**ADDENDUM NO. 1**

**Chairlift Modernization:**

**Damascus Elementary School**

February 19, 2021

**1**  
A5.1 **ELEVATION OF LIFT FROM LOWER LANDING**  
SCALE: 1/2" = 1'-0"

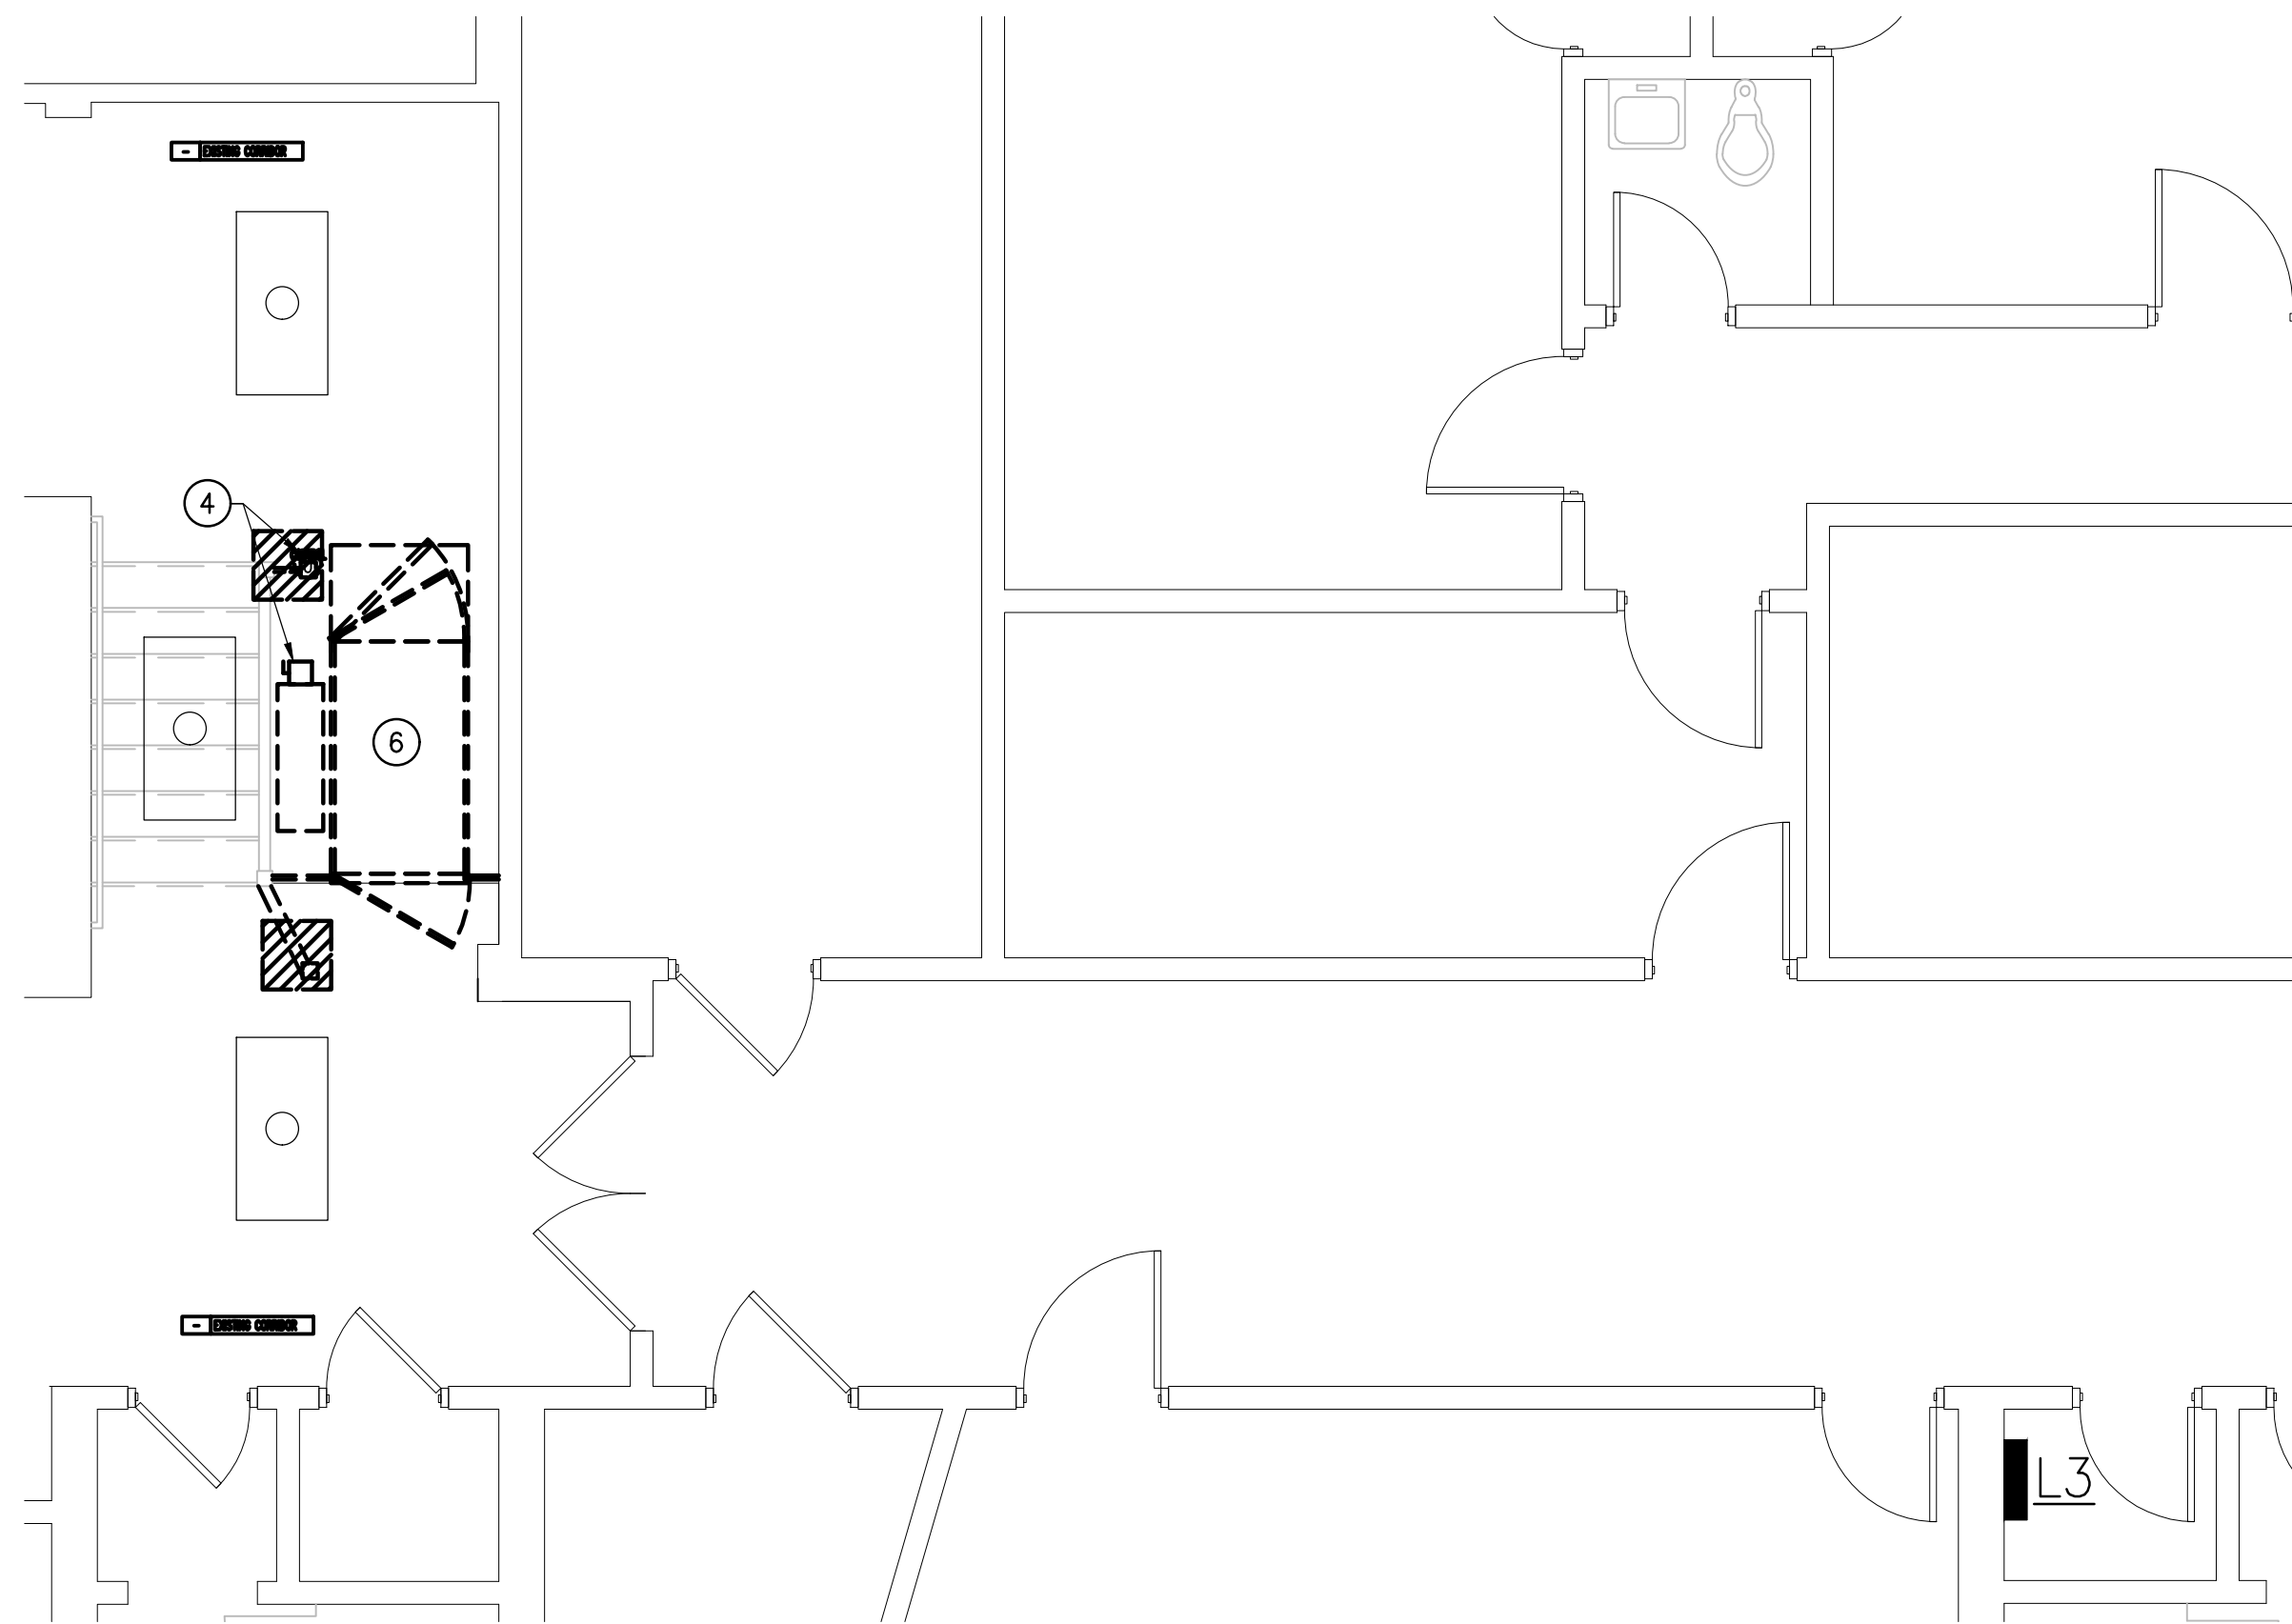
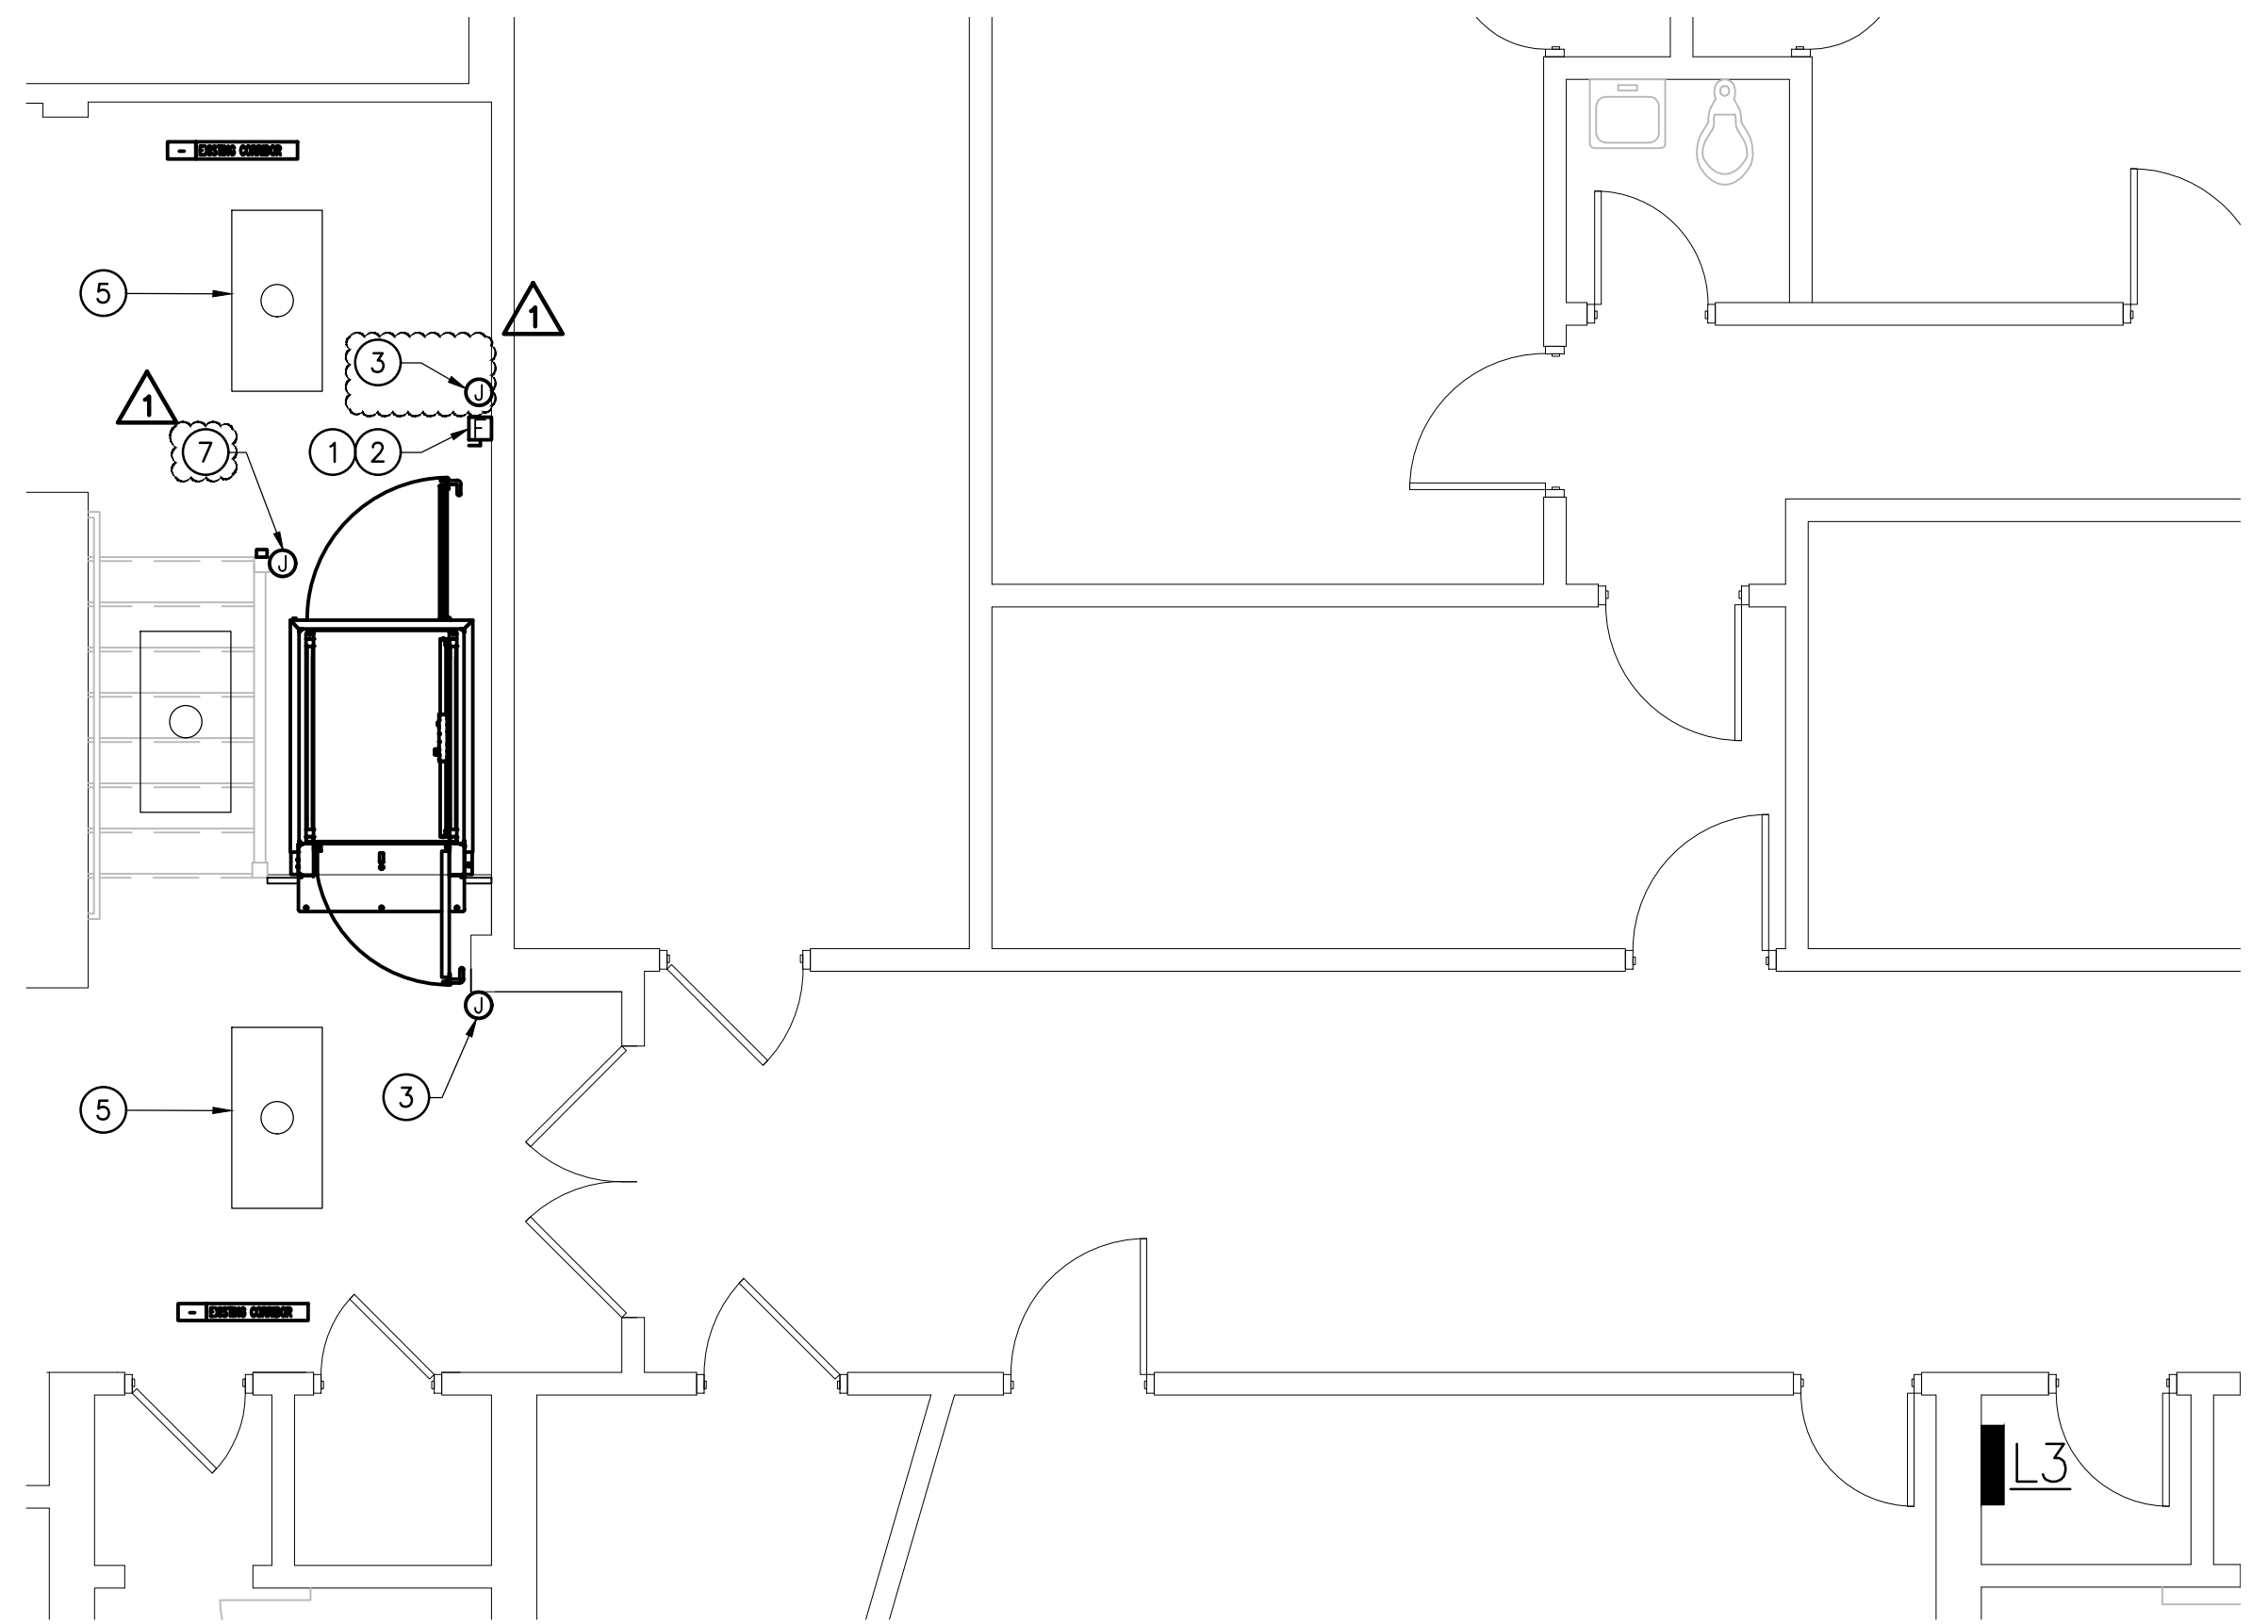
- A1.1 – Handrails on both sides of existing stairs are non-compliant with current codes for height, grip, and location. Drawing A1.1 is revised to demolish the handrail and guardrail on both sides of the existing stair in its entirety and replace with a new code compliant handrail/guardrail.
- A5.1 – Notes pertaining to the above mentioned handrail/guardrail replacement. Existing ceiling slope does not meet required ceiling clearance heights over full extent of new chairlift. Reframe ceiling to meet the 80” required clearance.
- E1.1 – Add “Call Attendant” buttons to connect back to main office.
